**City of Bellevue
Development Services Department
Land Use Staff Report**

Proposal Name: Captain Residence

Proposal Description: Proposal to construct a new single-family residential structure within a steep slope, steep slope buffer, and steep slope structure setback. The proposal includes mitigation and restoration planting, and is supported by a critical areas report and geotechnical report.

File Number: 20-110765-LO

A1.1

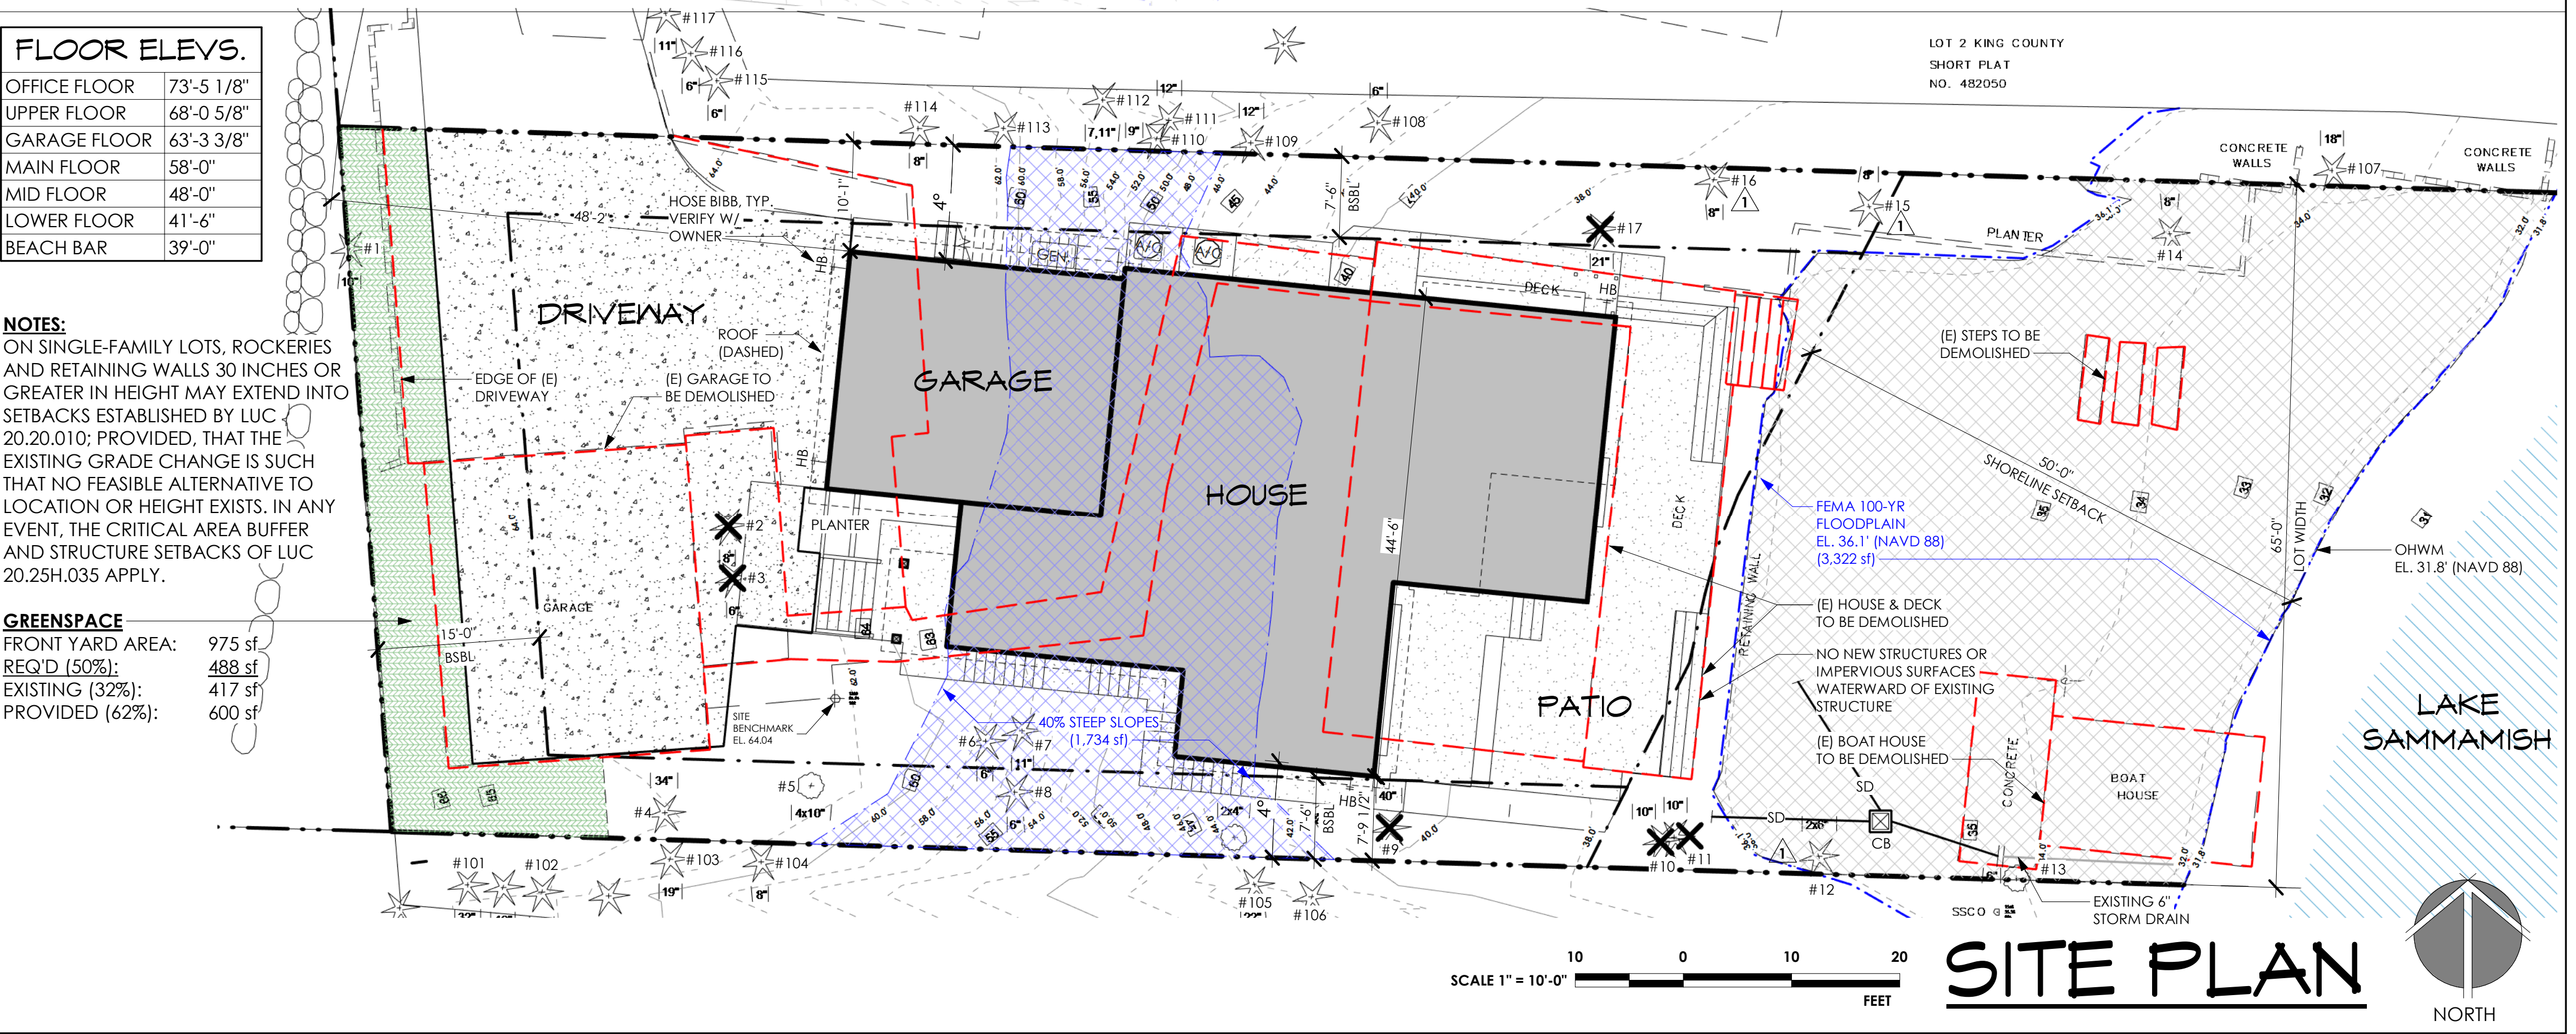
4. Front Yard Setback and Greenscape: The front yard setback applied shall be the full 20 feet as required by LUC 20.20.010 for properties zoned R-3.5. The project shall provide at least 50% greenspace based on the front setback area. Conformance with these requirements is required for Building Permit approval.
